**STATE OF CONNECTICUT
CONNECTICUT SITING COUNCIL**

PETITION NO. 1598 – Windsor Solar One, LLC petition for a declaratory ruling, pursuant to Connecticut General Statutes §4-176 and §16-50k, for the proposed construction, maintenance and operation of a 3.0-megawatt AC solar photovoltaic electric generating facility located at 445 River Street, Windsor, Connecticut, and associated electrical interconnection.	Petition No. 1598
	January 23, 2024

Petitioner Windsor Solar One, LLC (“WSO” or “Petitioner”) hereby submits the following responses to the Interrogatories that were directed to WSO by the Connecticut Siting Council (“Council”) on January 9, 2024.

Public Water Supply Map

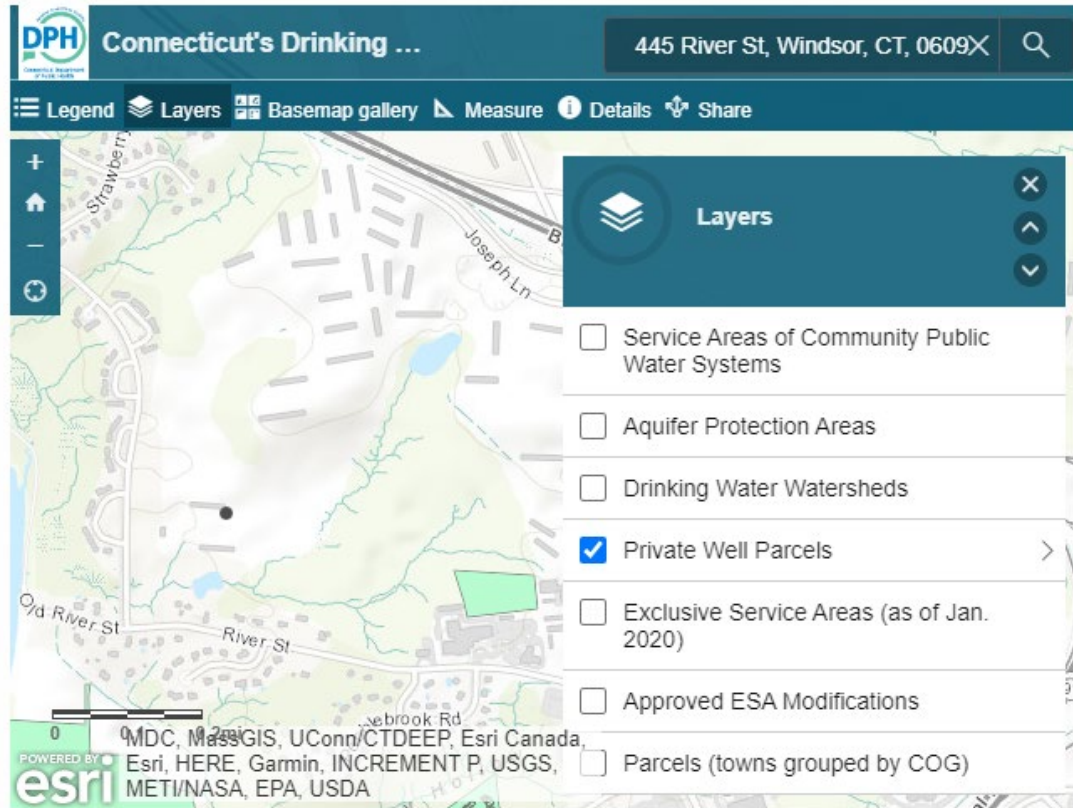
44. Are there any water supply wells in the vicinity of the site? If yes, would the installation of racking posts affect well water quality from construction impacts, such as vibrations and sedimentation?

Figure 7 of the Petition materials shows property limits for this project overlaid on the State of Connecticut's Public Water Supply Map and indicates that the bulk of the site and surrounding properties are "Service Areas of Community Public Water Systems". An additional check of this map confirms that there are no private wells in the vicinity of the site, see image below. Thus, water quality impacts are not anticipated.

Photo Location Map

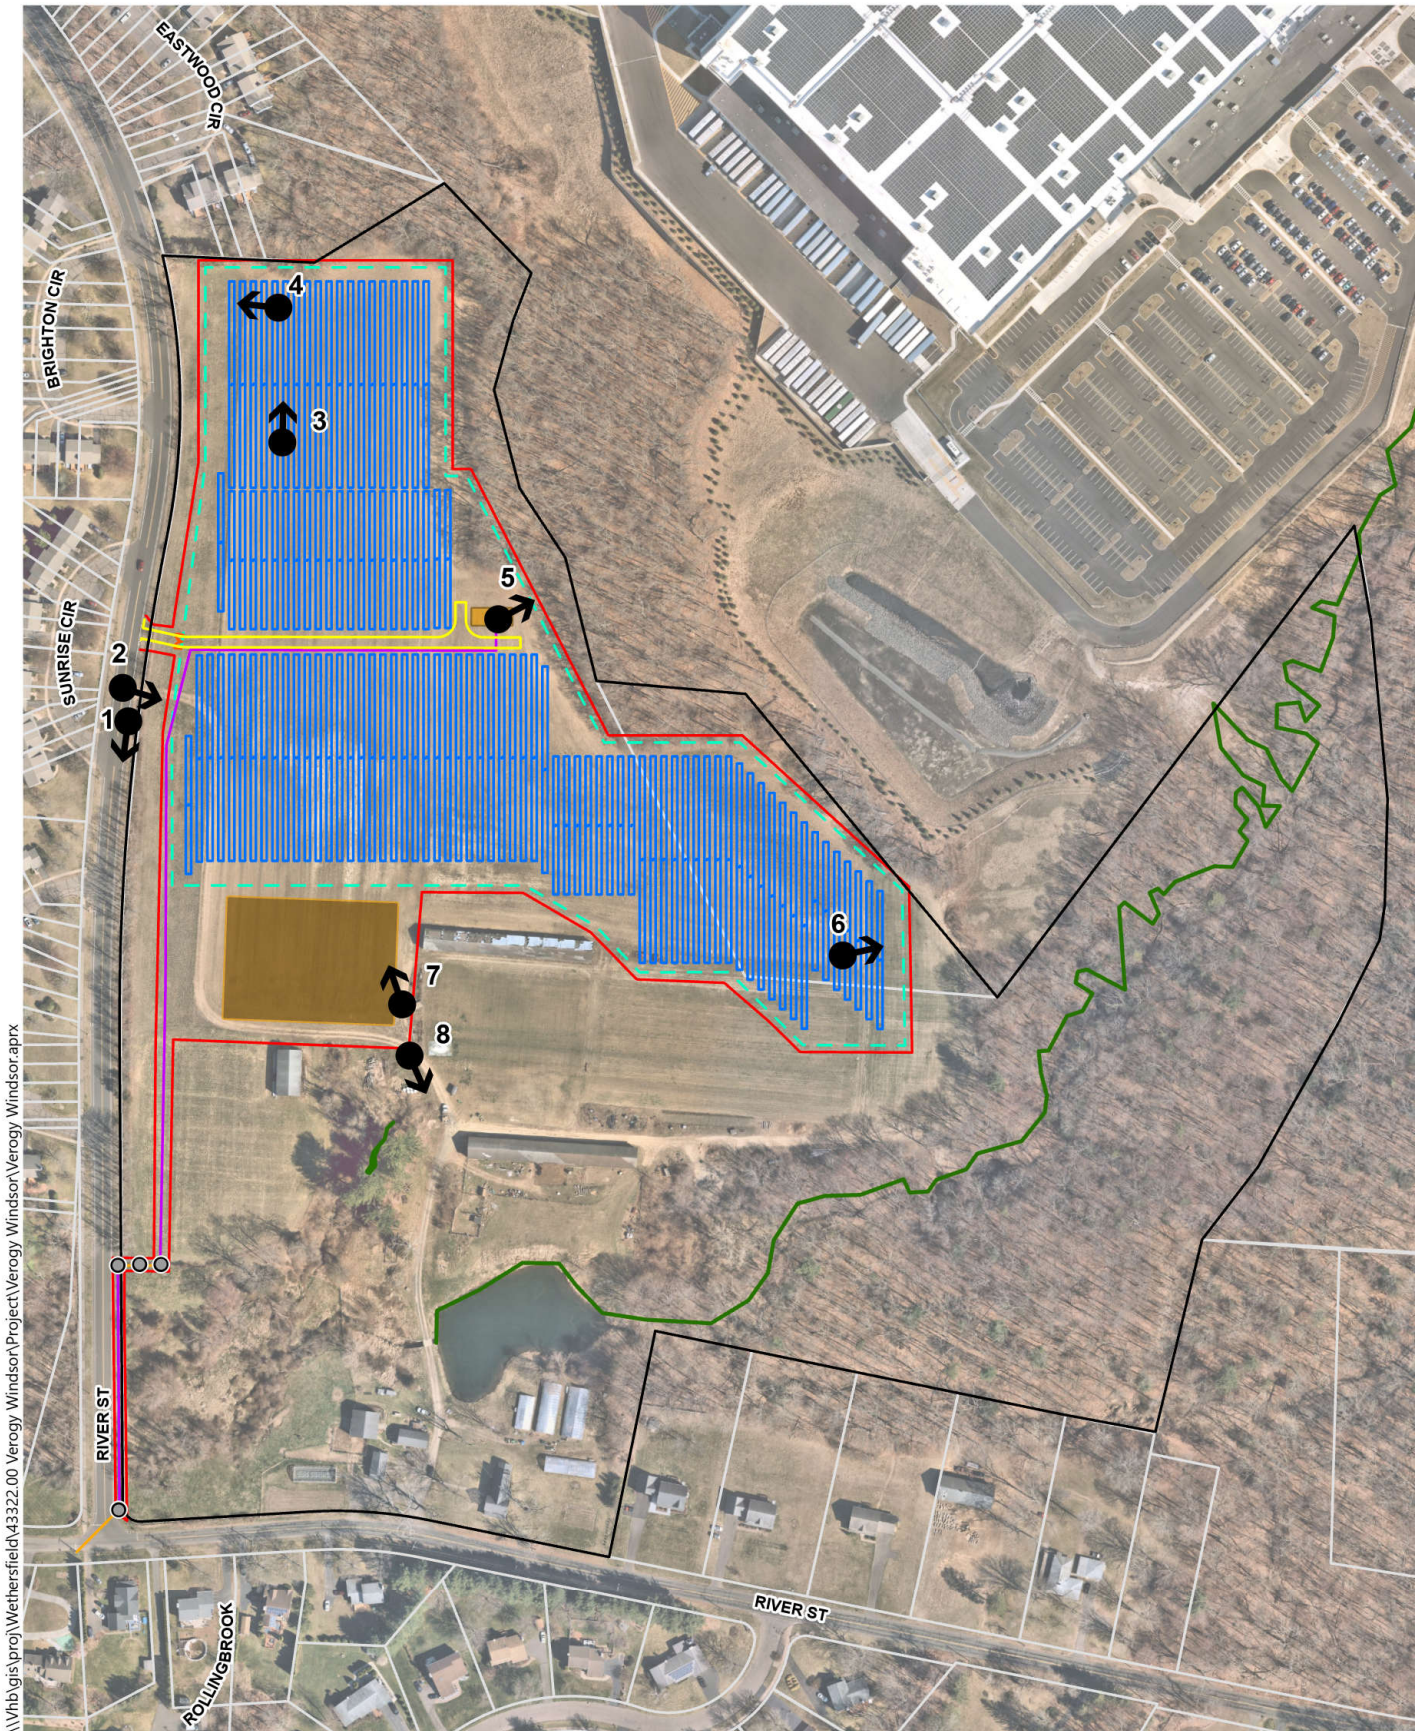
51. Submit photographic site documentation with notations linked to the site plans or a detailed aerial image that identify locations of site-specific and representative site features. The submission should include photographs of the site from public road(s) or publicly accessible area(s) as well as Site-specific locations depicting site features including, but not necessarily limited to, the following locations as applicable:

A photolog graphic must accompany the submission, using a site plan or a detailed aerial image, depicting each numbered photograph for reference. For each photo, indicate the photo location number and viewpoint direction, and clearly identify the locations of site-specific and representative site features show (e.g., physical staking/flagging or other means of marking the subject area).

The photo plan produced by VHB is attached hereto as **Exhibit A**.
